**Town of Nags Head Planning Board
Nags Head Municipal Complex Board Room
Tuesday, June 18, 2024; 9:00 a.m.**

Subject: Site Plan Amendment for Inn at Whalebone, 87-unit Hotel located at 6632 W. Pheasant Avenue (W. Lakeside Street).

**TRAFFIC IMPROVEMENTS
FOR W. LAKESIDE ST.**

TURN LANE EXHIBIT

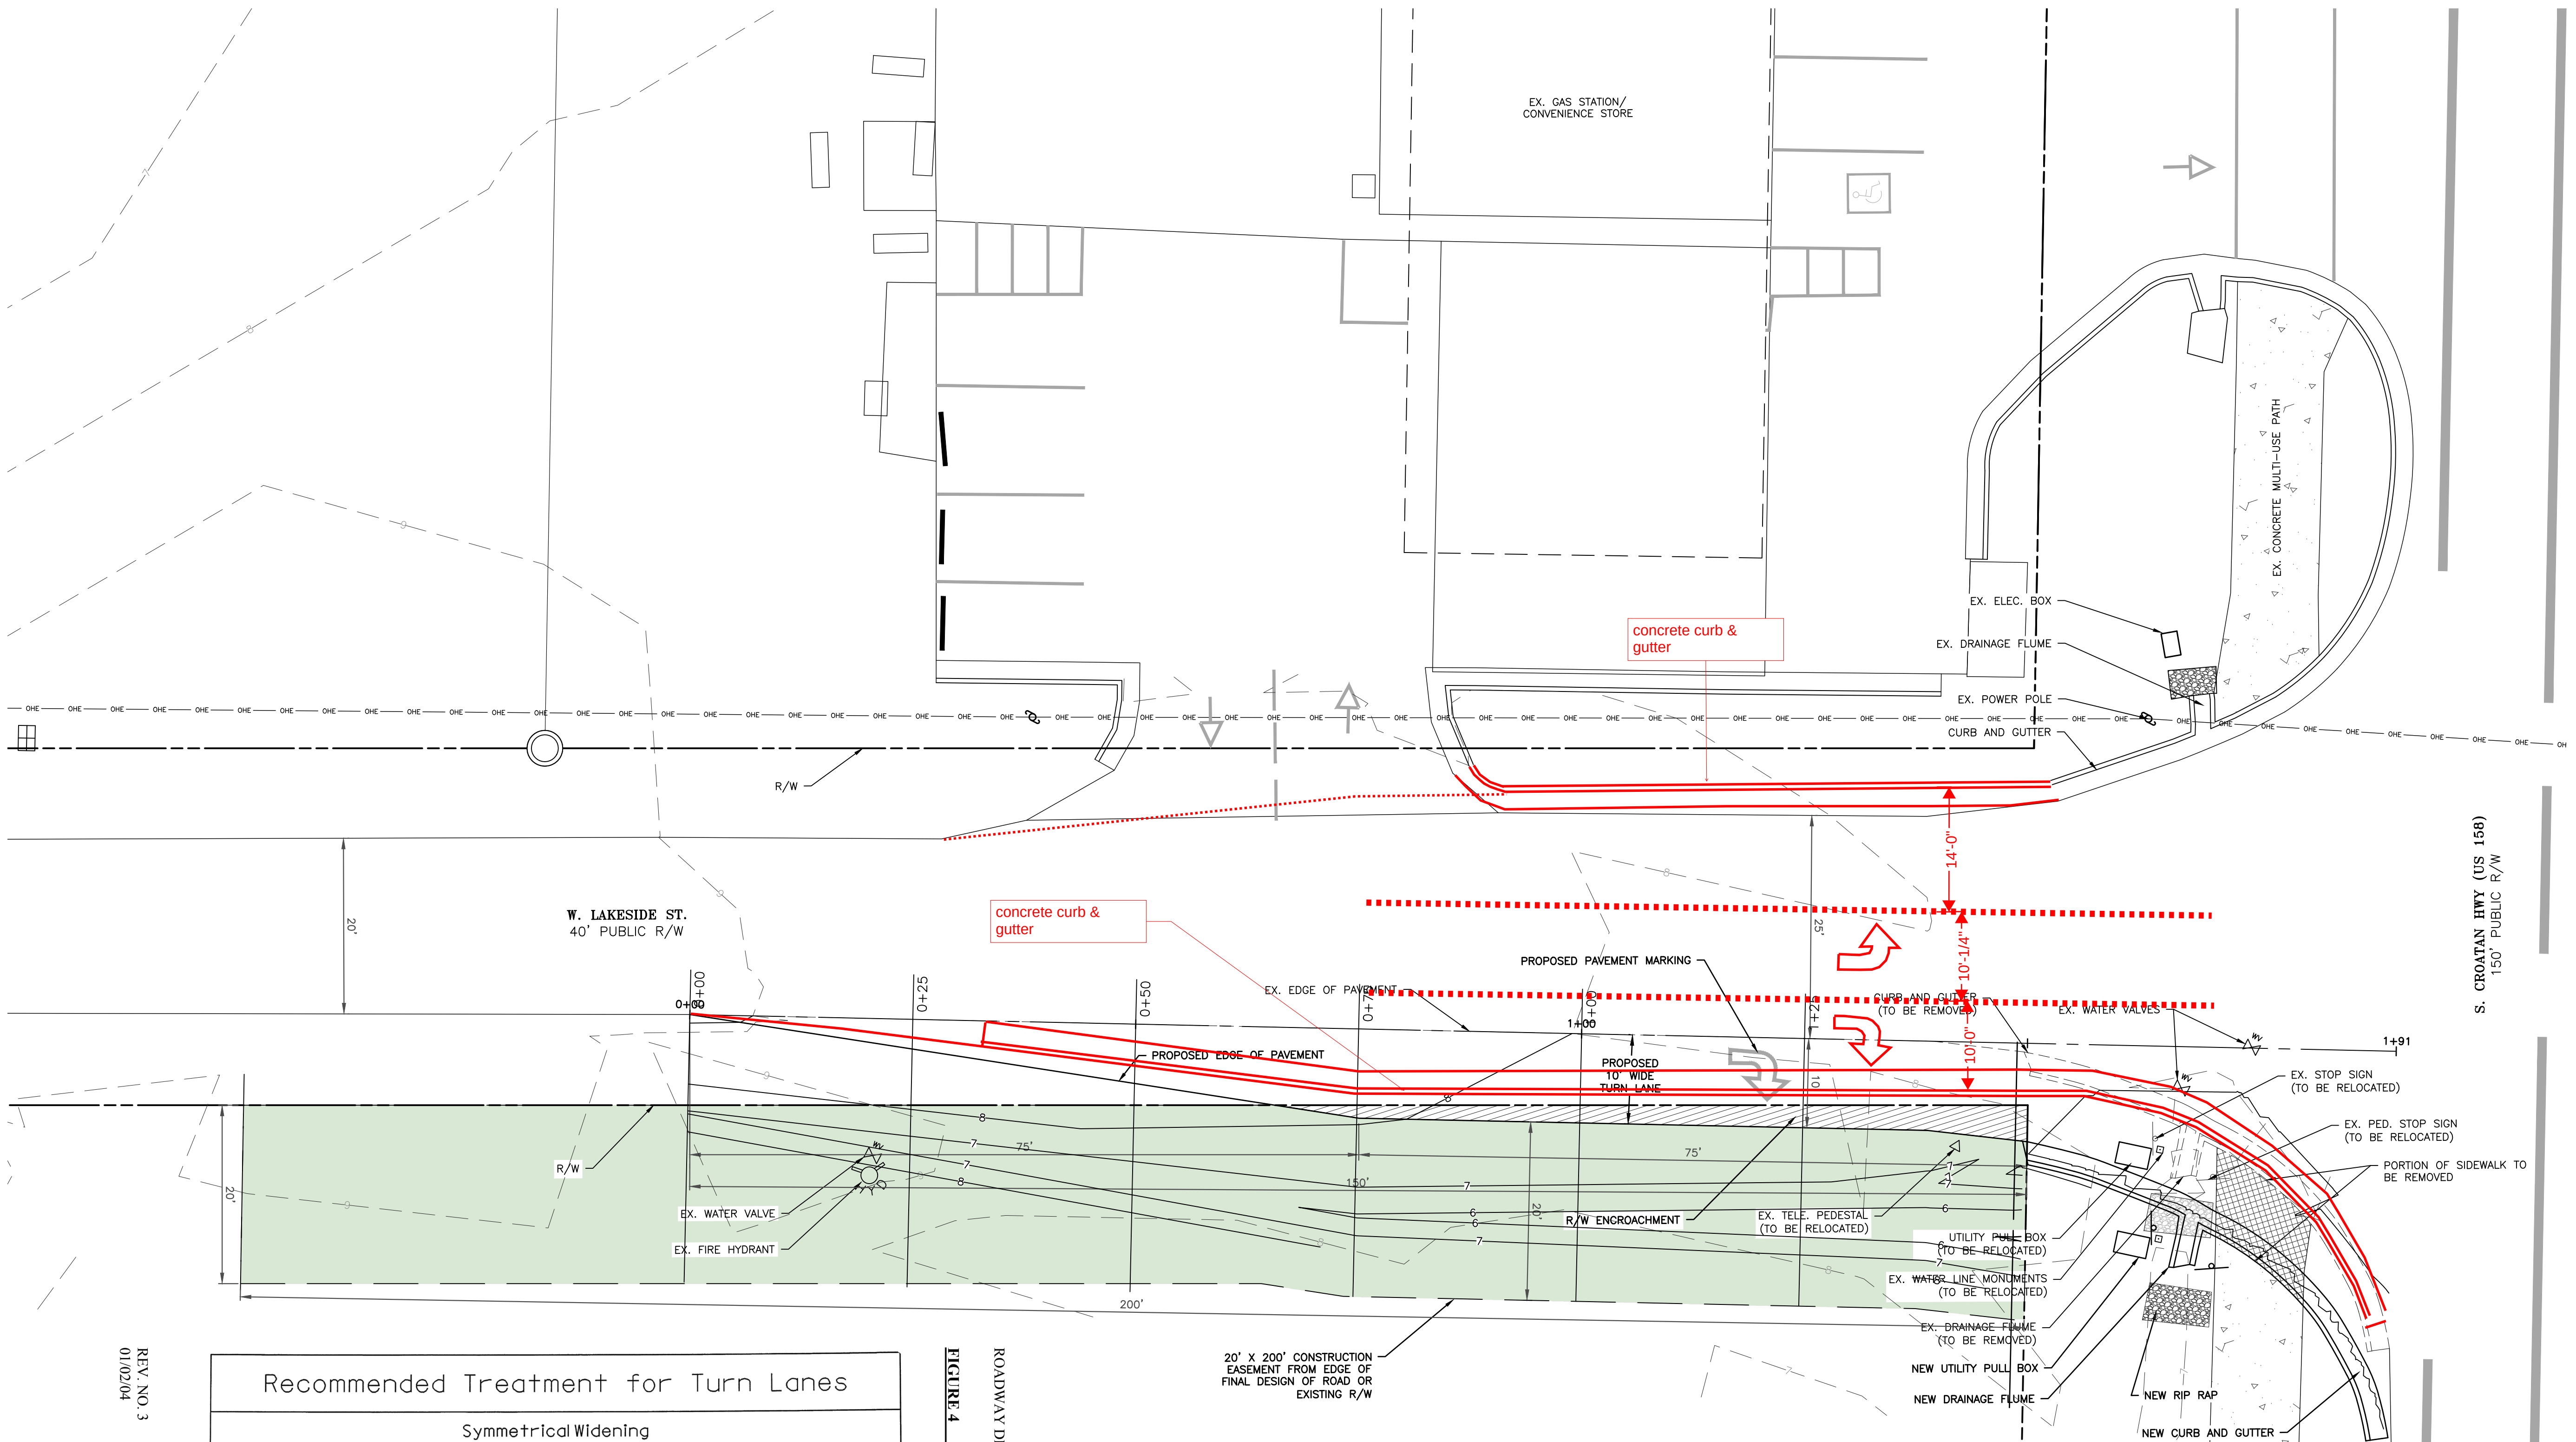
“Lakeside Street Turn Lane Exhibit- A condition was placed on the previous site plan approval to widen the Lakeside St roadway extending from S. Croatan Hwy. to the westernmost boundary of the subject property. With the existing Lakeside St. right-of-way width at 40’ there are some impacts associated with a roadway widening of this length. These impacts include runoff onto adjoining properties and potential conflicts with above ground utilities. However, there is still an opportunity to provide roadway widening to meet the intent of the previous Board of Commissioners conditioned approval.

The applicant has submitted an exhibit which shows a reduced widening plan from the eastern property boundary. This concept indicates an encroachment onto the adjoining undeveloped property to the south. Attached is an exhibit mark-up which describes a potential alternative roadway widening approach which may not result in improvements extending onto private property. The recommendation is for the applicant to modify the traffic improvements for Lakeside St. to reflect the approach as identified in the attached plan mark-up. This approval would be conditioned on the applicant acquiring detailed survey information for the development of a roadway widening and construction plan in accordance with Chapter 36-4 of the Town Code of Ordinances. It should be noted that a temporary construction easement may be required from the owner of the undeveloped property to the south for the purposes of construction in addition to a right-of-way encroachment through NCDOT.”

Regarding the applicant's request to remove or modify the condition to widen Lakeside Street, this condition was included in the October 4, 2023, Board of Commissioners (BOC) approval to address traffic concerns raised by citizens and Board members. While fully meeting this condition could impact runoff onto adjacent properties and conflict with above-ground utilities, there is an opportunity to widen a portion of the roadway. This approach would fulfill the intent of the Board of Commissioners' conditioned approval without encroaching on adjoining properties. Staff recommends that the Planning Board recommend modifying the previous BOC approval to reflect the alternative roadway design proposed by the Town Engineer.

PROJECT NUMBER	DRAWING NUMBER
C06001.00	C-102

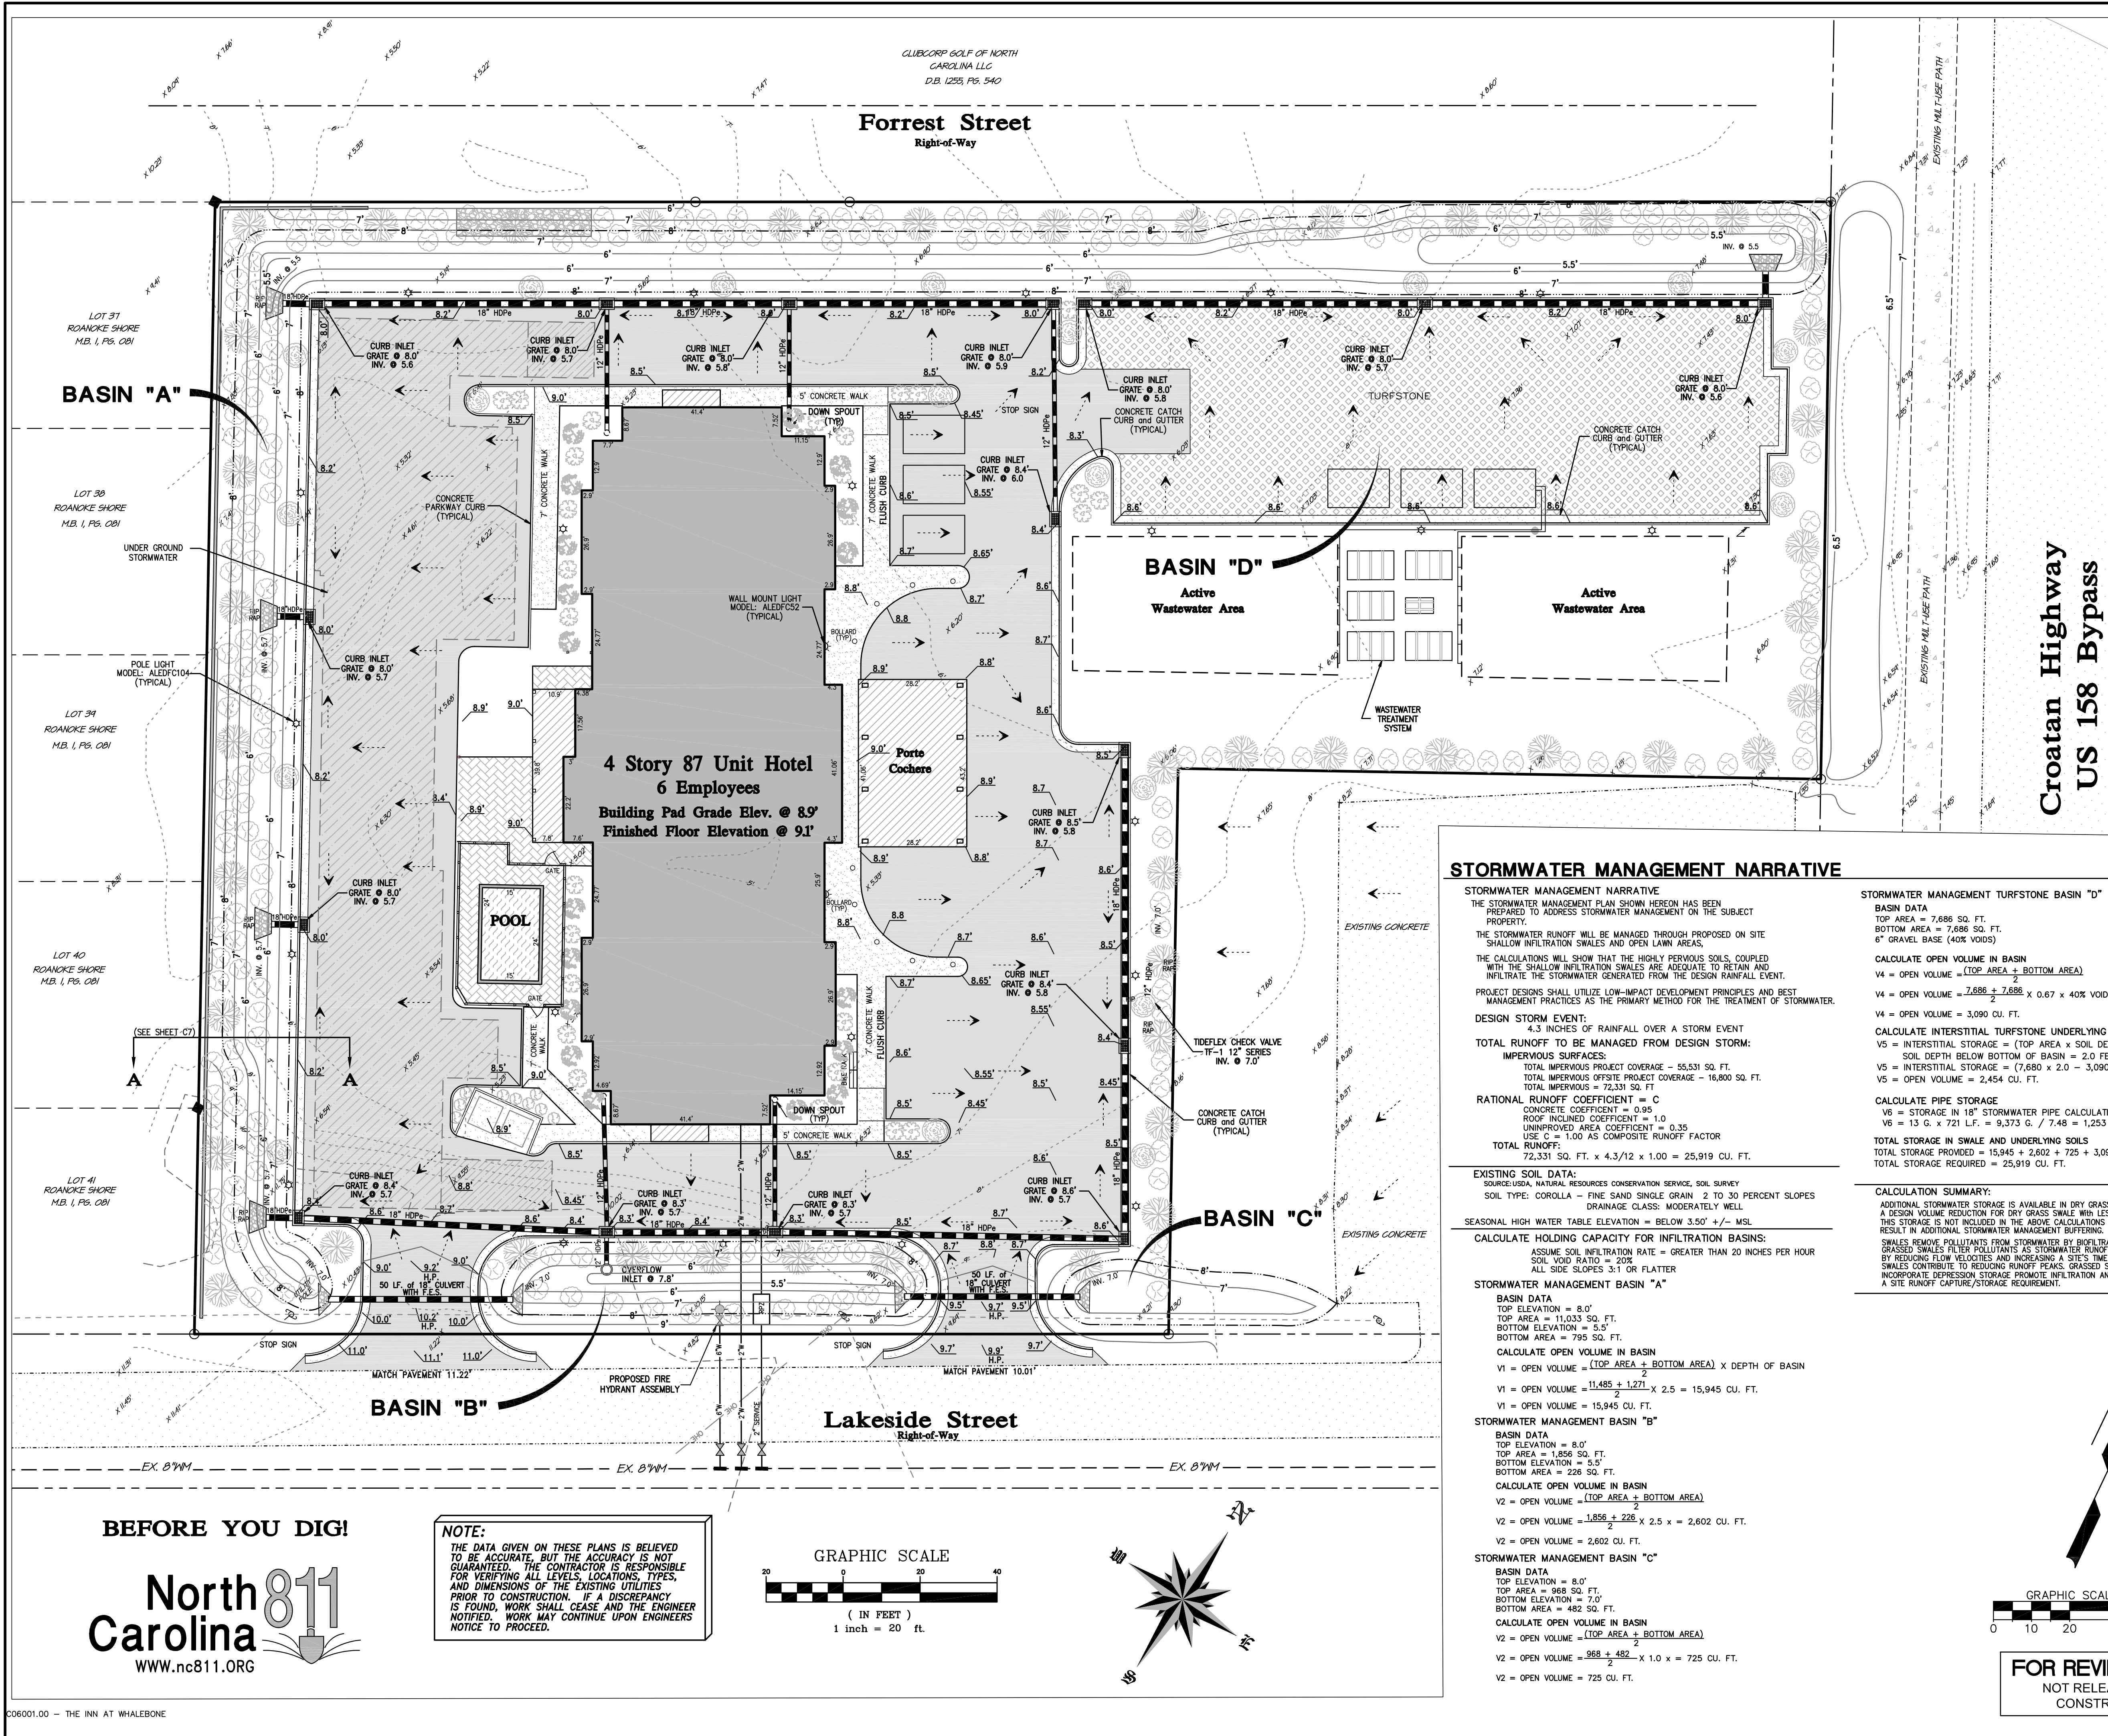
Town Engineer David Ryan has reviewed the revised plans and notes that the stormwater narrative on Sheet C-103 indicates a Seasonal High Water Table Elevation of 3.50' MSL. The typical infiltration basin detail indicates a SHWL of 4.8'. This discrepancy should be clarified. The stormwater management design information submitted appears to be in substantial compliance with the Town of Nags Head Unified Development Ordinance.
